# Safety Bulletin

Stop using Braided Safety Blue® with slaiice®, Arbor Elite with slaiice® and pottsblitz with slaiice®, CEclimb 12 with slaiice®:

Issue date	25 <sup>th</sup> September 2019	Ref. No	UAG062
------------	---------------------------------	---------	--------

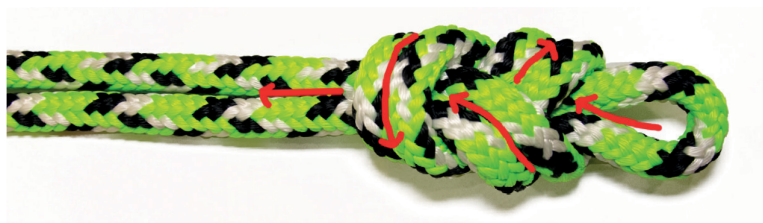
1. Retire slaiçe® from use! Mark clearly and unambiguously as "not for use"!
2. Cut off the slaiçe by 50 cm minimum

3. You may continue using your rope with a figure-8-knot instead. Mind the course of the load bearing rope section (arrow). Deviating knot design considerably reduce the breaking load.  
**You are not allowed to make any other termination!**
